AMATEUR SERVICE AGENCY BULLETIN NO. 1012

EQUIPMENT TYPE: 30S-1

SUBJECT: INTERMITTENT DROPOUT OF PLATE OVERLOAD RELAY

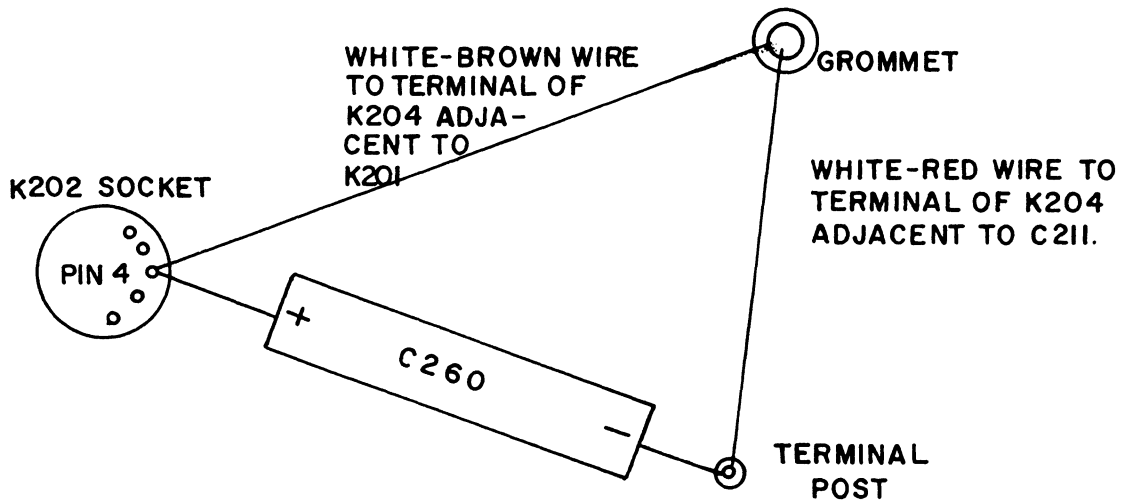
Some linear amplifier owners have experienced trouble with the plate overload relay, K204, occasionally dropping out during SSB operation. Sharp, fast rising voice characteristics that are passed before the exciter alc can respond, cause peak instantaneous plate currents in excess of one ampere in the amplifier tube, 4CX1000A. These peaks do not harm the tube but do occasionally cause the plate overload relay to energize which cuts off the plate high voltage.

If this phenomenon is encountered, we suggest installing a capacitor, 2000 uf, 6 volt electrolytic, across the coil of relay K204. This capacitor may be installed on the under side of the relay shelf and mounted between an unused terminal of socket for relay K202 and an insulated terminal post. The added wires are approximately 10 inches long.

The addition of this capacitor makes the overload circuit a very low impedance to audio frequency changes in plate current while still providing the desired overload protection for the PA tube. The change has been made in current production of 30S-1's.

1. Remove and turn relay shelf so as to gain access to lower side of shelf.
2. Remove and replace mounting nut for relay, K204, with terminal post, 306-0978-00.
3. Install capacitor and add wires per diagram.
